ALERT SERVICE BULLETIN

505-25-46
PSL #2691
10 June 2025

MODEL AFFECTED: **505**

SUBJECT: **PILOT AND COPILOT CYCLIC AND COLLECTIVE STICK ASSEMBLIES, INSPECTION, REWORK, AND INTRODUCTION OF AIRWORTHINESS LIFE LIMITATION.**

Figure 7 – Areas of sealant application

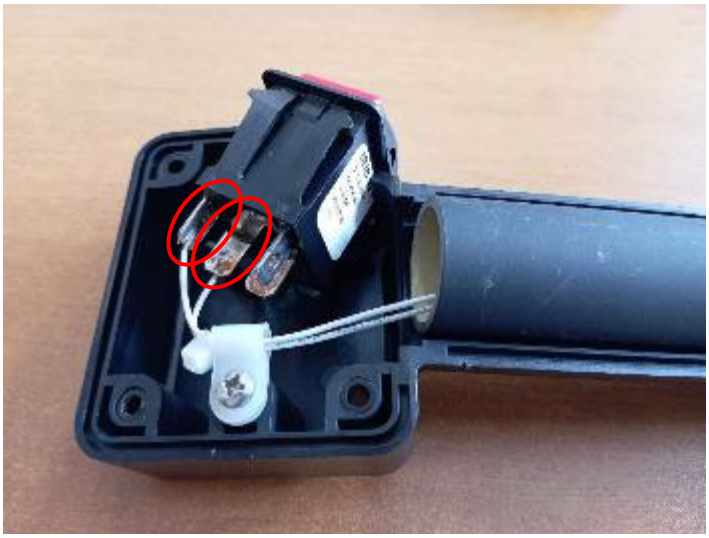
14. Refer to Figure 7. Apply a continuous layer of Sealant DOWSIL 732 RTV, clear color on both sides of the two soldered terminals (both on the switch).

Figure 12 – Marking area – Stick assembly

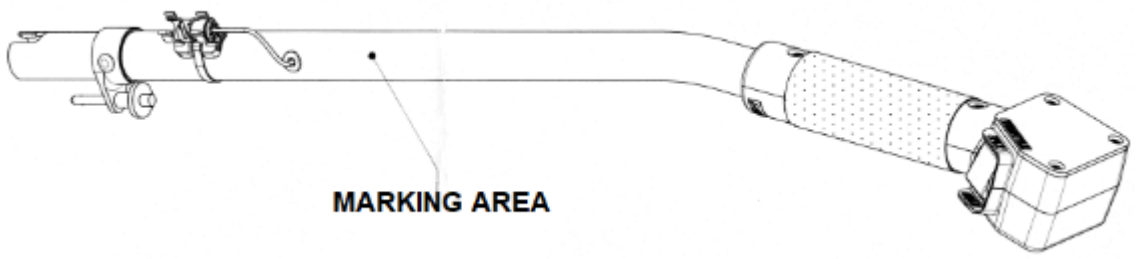
31. Refer to Figure 12. Strikethrough with a white permanent ink marker or remove with an abrasive pad the last digits (-047) of the co-pilot collective stick assembly P/N M207-20M479-047.

32. Update the P/N with a white permanent ink marker close to the existing P/N. Mark as follows:

a. Mark the last digits (-051) of the P/N M207-20M479-051.

b. If you are reworking parts on-field, add FM after the co-pilot collective stick assembly P/N.

Figure 19 – Areas of sealant application

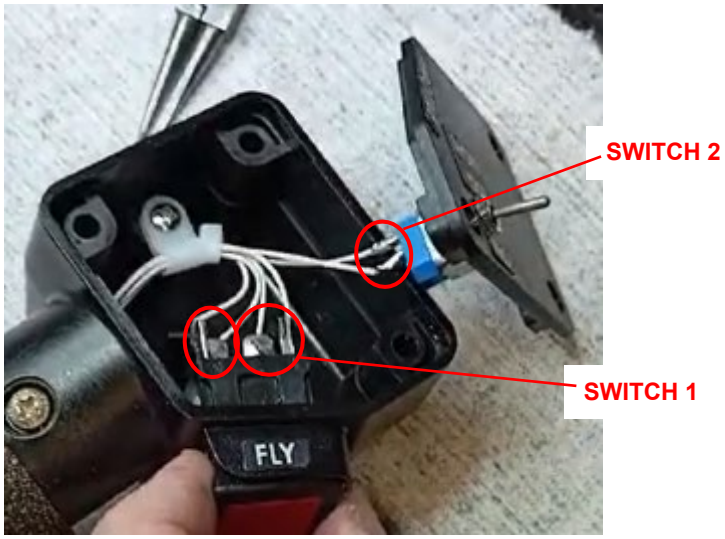
14. Refer to Figure 19. Apply a continuous layer of Sealant DOWSIL 732 RTV, clear color on both sides of the six soldered terminals (four on the switch 1 and two on the switch 2).

Figure 24 – Marking area

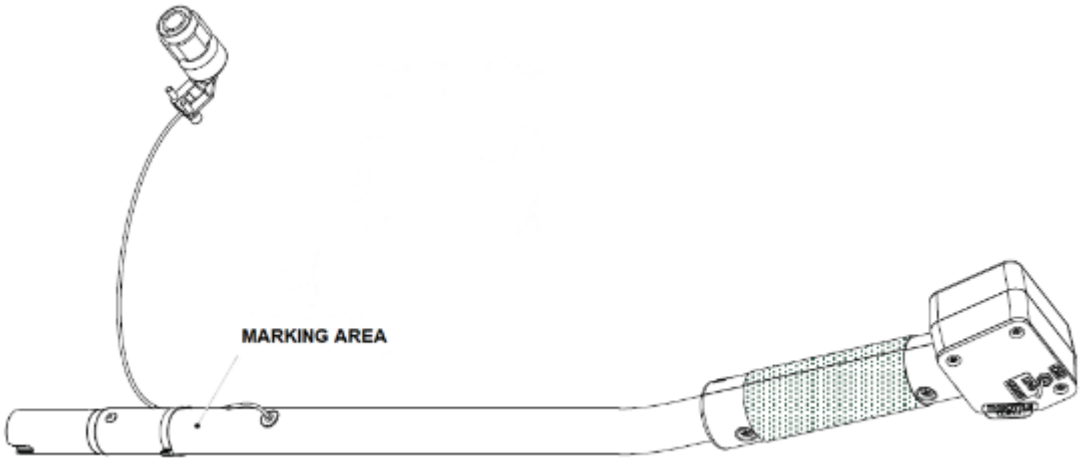
28. Refer to Figure 24. Strikethrough with a white permanent ink marker or remove with an abrasive pad the last digits (-051/-053) of the pilot collective stick assembly P/N M207-20M478-051/-053.

29. Update the P/N with a white permanent ink marker close to the existing P/N. Mark as follows:

a. Mark the last digits (-055) of the P/N M207-20M478-055.

b. If you are reworking parts on-field, add FM after the pilot collective stick assembly P/N.

Figure 32 – Areas of sealant application

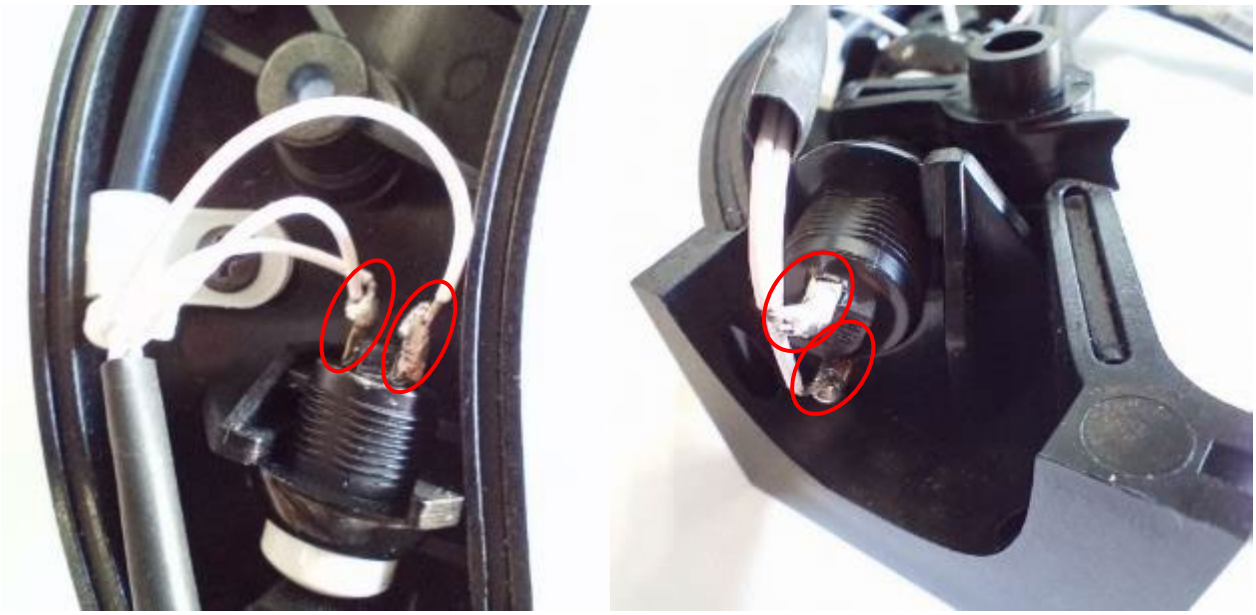
14. Refer to Figure 32. Apply a continuous layer of Sealant DOWSIL 732 RTV, clear color on both sides of the four soldered terminals (two on the white switch and two on the black switch).

Figure 35 – Marking area of the pilot cyclic grip & stick assembly

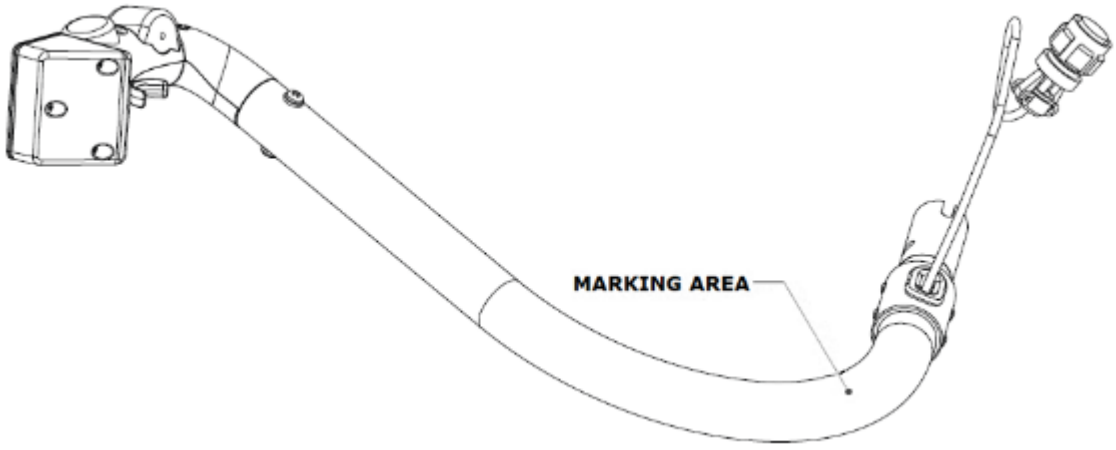
a. Refer to Figure 35. Strikethrough with a white permanent ink marker or remove with an abrasive pad the last digits (-045) of the Pilot cyclic stick assembly P/N M207-20M476-045.

b. Update the P/N with a white permanent ink marker close to the existing P/N. Mark as follows:

- Mark the last digits (-049) of the P/N M207-20M476-049.
    - If you are reworking parts on-field, add FM after the cyclic stick assembly P/N.

Figure 36 – Marking area of the co-pilot cyclic grip & stick assembly

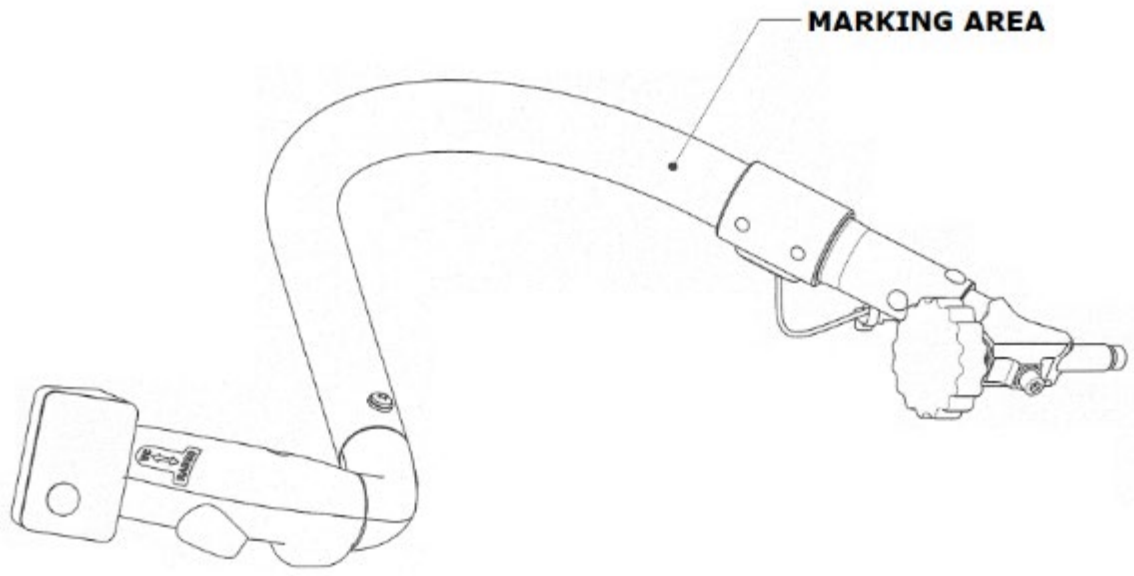
a. Refer to Figure 36. Strikethrough with a permanent ink marker or remove with an abrasive pad the last digits (-045) of the Co-pilot cyclic stick assembly P/N M207-20M477-045.

b. Update the P/N with a white permanent ink marker close to the existing P/N. Mark as follows:

- Mark the last digits (-049) of the P/N M207-20M477-049.
- If you are reworking parts on-field, add FM after the cyclic stick assembly P/N.
